Editor's Report – Proposal Summary

George Zimmerman / CME Consulting, Inc.

11/18/2020

Figure 147-7 (excerpt)

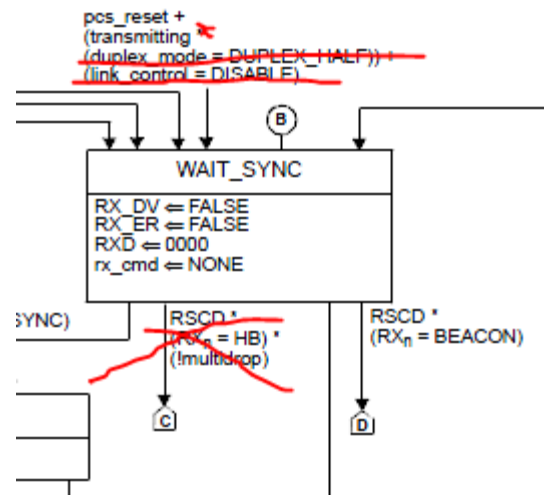
- Fig 147-7: delete exit “C” from WAIT_SYNC; Fig 147-8: delete “HEARTBEAT” states that “C” goes to
